<b>TRI-PARTY AGREEMENT</b>		
Change Notice Number TPA-CN- 0738	TPA CHANGE NOTICE FORM	Date: 8/5/2016
Document Number, Title, and Revision: Removal Action Work Plan for River Corridor General Decommissioning Activities, April 2013, DOE/RL-2010-34, Rev. 2 <span style="float: right; font-size: 1.2em;">1220239</span>		Date Document Last issued: 4/8/2015
Approved Change Notices Against this Document TPA-CN-706		
Originator: R.F. Guercia		Phone: 509 376-5494
<b>Description of Change:</b> Adds 10 buildings associated with the Research Technology Laboratory to the General Decommissioning RAWP.		
<p>RF Guercia _____ and D. Einan &amp; S. Schleif _____ agree that the proposed change  <span style="margin-left: 100px;">DOE</span> <span style="margin-left: 100px;">Lead Regulatory Agency</span></p> <p>modifies an approved workplan/document and will be processed in accordance with the Tri-Party Agreement Action Plan, Section 9.0, <i>Documentation and Records</i>, and not Chapter 12.0, <i>Changes to the Agreement</i>.</p> <p>The following change is authorized:          Replace pages 1-1, 1-2, 1-3, 1-8, 1-9 and 1-11 with attached.          Added text is shown in <u>double underline</u>.</p> <p>Note

Figure 1-1. Hanford Site Map.

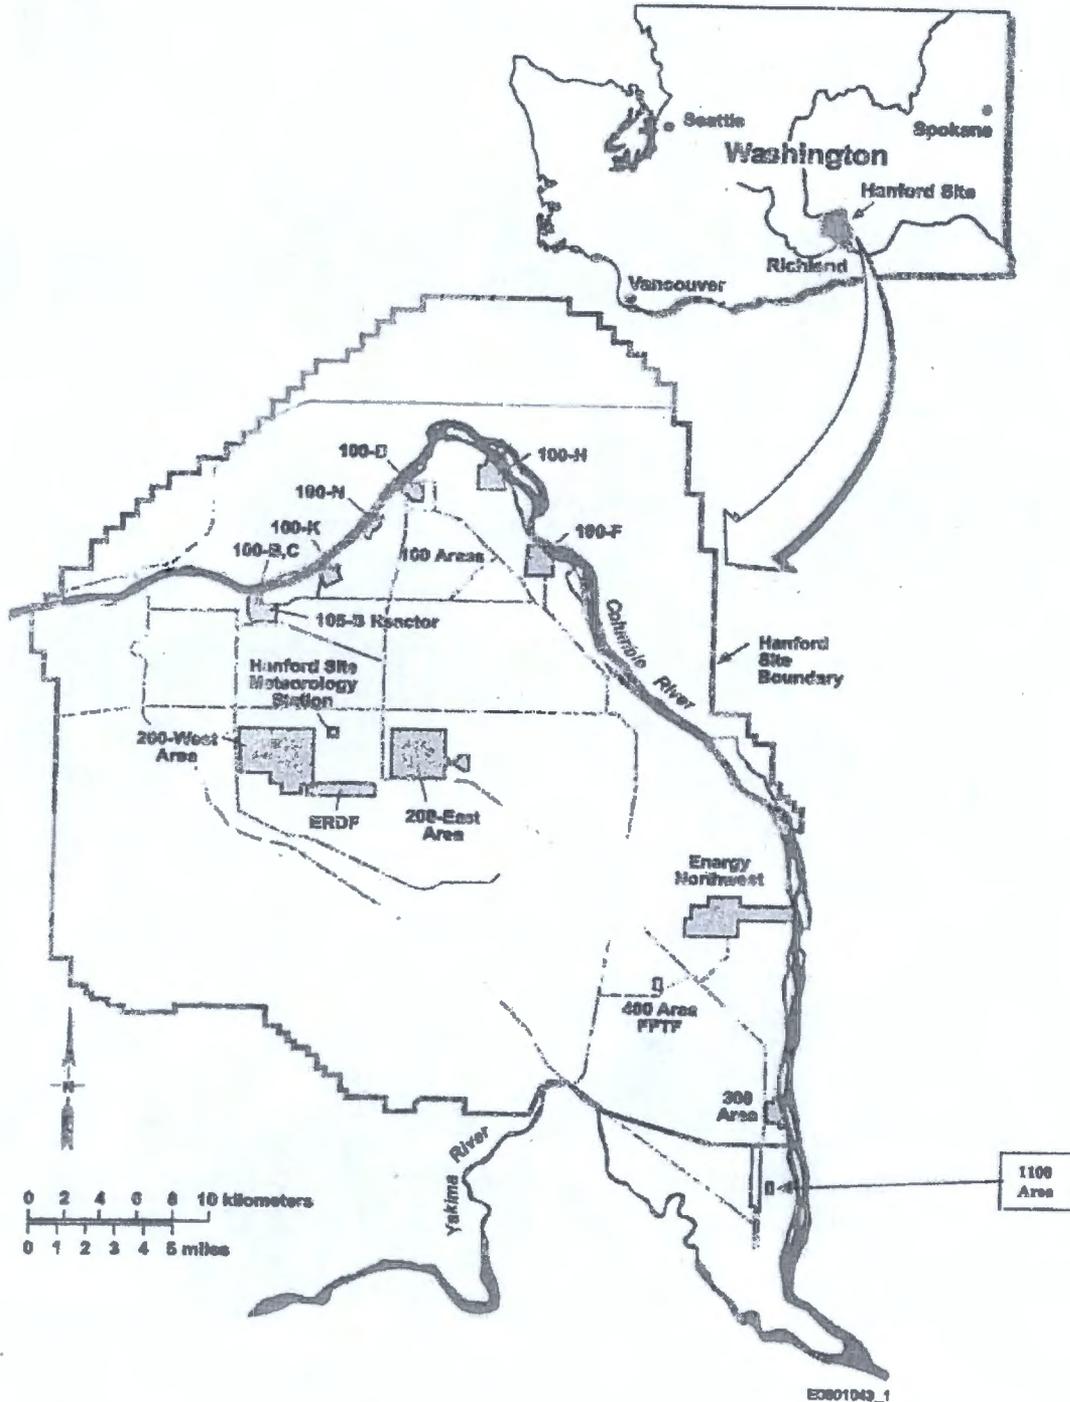
Add a new Figure 1-1 to show location of the 1100 Area

These areas include the 100 Areas, 300 Area, 400 Area, 600 Area and 1100 Area (Figure 1-1).
